RE: Nursery Products - Design Plan

On behalf of Nursery Products, this letter responds to the letter of February 23, 2012 ("Letter") from the Regional Water Quality Control Board, Lahontan Region ("Water Board") regarding the Design Plan for the Nursery Products Hawes Compost Facility ("Hawes Facility"). The Design Plan was originally submitted May 5, 2010 and the Water Board has had only two issues (as addressed further below) but has sent eight letters over the course of two years regarding the Design Plan. The latest version of the Design Plan was submitted January 24, 2012 and that version is referenced further in this letter. In addition to responding to the Letter, this response describes the Water Board's pattern of raising new or incremental comments on previously approved portions of the Design Plan. Because of the pattern, as well as the delays, it is difficult to believe that Nursery Products will receive treatment that will result in the approval of the Design Plan.

SURFACE IMPOUNDMENT PERIMETER ANCHORAGE (SHOWN AT DIVERSION BERM OPENING)
NOT TO SCALE

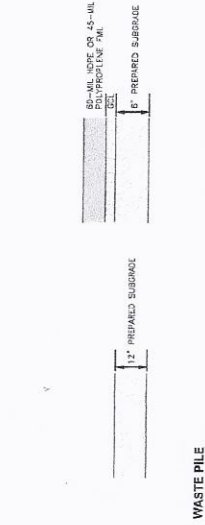
As described in detail in the latest version of the Design Plan, in response to Water Board's demands and after numerous iterations, a metal plate will extend over the 90% compacted soil and act to extend the spillway directly in to the surface impoundment. The metal plate will extend over 3-feet from the end of the concrete and completely cover the unpaved surface area. The metal plate will extend beyond the edge of the surface impoundment itself without touching the liner of the impoundment. This overlap will provide ample distance for gravity to act on any water that may course over the metal plate. To put the area covered by the metal plate in fuller perspective, the metal plate will be located only at two 10-foot openings in the diversion berm for the eastern surface impoundment and a single 20-foot opening in the diversion berm for the western surface impoundment 40 square feet [(10' +10'+20') X 1] on a site of 80 acres.

The February 23rd letter states that the Design Plan "does not meet the requirements of the Board Order." This statement is so general as to be meaningless and one could just as easily argue the opposite. Clearly the Order is silent on such details. The Letter goes on to reference the "areas between the concrete aprons located at the base of the surface impoundment diversion berms, and the edge of the liner of the surface impoundments" and mentions the metal plate that was proposed by Nursery Products in the fall and incorporated into the January 24th Design Plan to be attached to the downstream edge of the concrete apron. The metal plate was in fact proposed last August 22, 2011 after a proposal that included a water resistant geoweb material (which had been proposed because of the difficulty of construction and potential for damage to the liner of the impoundment which is anchored at this location and because the Water Board had expressed a concern about erosion in this area) had been rejected by the Water Board. As set forth in the September 22, 2011 letter, the Water Board accepted any of three designs including the metal plate (and two other designs) but requested additional revisions to the metal plate. Those revisions were made in the January 24, 2012 submittal by Nursery Products. The Letter now raises an additional issue: the absence of "a seal or liner ... at the point of contact with the metal plate." Thus, having yet again met the Water Board's request for

The Water Board Letter raises a new issue by stating that "a seal or liner is not proposed at the contact with the metal plate and the concrete apron."(Emphasis added). This in spite of the fact that the Water Board letter of September 22, 2011 had approved, with certain conditions, a prior design that Nursery Products had provided with those requested alterations. Nonetheless, Nursery Products hereby includes a revised Page 6 of 9 to the Design Plan as Attachment A. This Substitution Page 6 of 9 to the Design Plan drawings shows the emplacement of a sealant material at the point of contact between the metal plate and concrete, in addition to the embedded emplacement and bolting of the plate as shown in the January 24th drawings. A seal will be obtained using an epoxy material between the concrete apron and the metal plate. The engineer has recommended sealing with Sikaflex-1a or an equivalent material as set forth on the enclosed substitution page. The attached complies with the Water Board's inferred, but never previously raised, basis for non-approval of the latest design and provides every reasonably available protection of this .001% area of the Facility.

REV	DESCRIPTION OF REVISION	BY	DATE	PROJECT	HCF	REVISION	DATE	REVISION
1	REVISION SECTION C TO INCLUDE EPOXY SEALANT	MSH	3/16/12	HAWES COMPOSITING FACILITY SAN BERNARDINO COUNTY, CA	JUN	JMS	5/19/11	3
2	REVISED SECTION C AND E	MHC	1/13/12					
3	MAY 2011 DESIGN DRAWINGS	MSH	5/19/11					
4	MARCH 2011 DESIGN DRAWINGS	MSH	2/21/11	PROJECT WORKSHEET	JUN	6	6	
5				DETAILS AND SECTIONS
